ECN/PCN No.: 4327

For Manufacturer			
<b>Product Description:</b> Oven Controlled Crystal Oscillator	<b>Abracon Part Number / Part Series:</b> AOCJY	<input type="checkbox"/> Documentation only	<input checked="" type="checkbox"/> Series
		<input checked="" type="checkbox"/> ECN	<input type="checkbox"/> Part Number
		<input type="checkbox"/> EOL	
<b>Affected Revision:</b> H	<b>New Revision:</b> I	<b>Application:</b>	<input type="checkbox"/> Safety
			<input checked="" type="checkbox"/> Non-Safety

**Part Number Builder:**

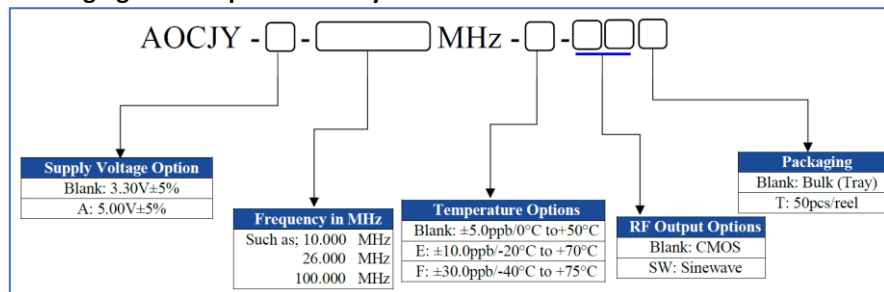
-Packaging for Bulk product= Tray

**Part Number Builder:**

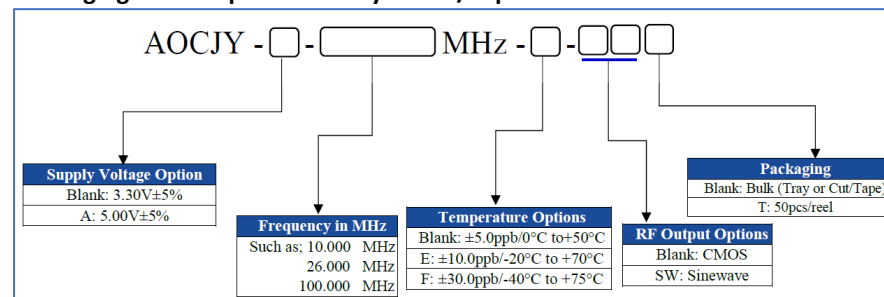
-Packaging for Bulk product= Tray or Cut/Tape

Standard product series review and upgrade. Updated packing method for higher volume quantities.
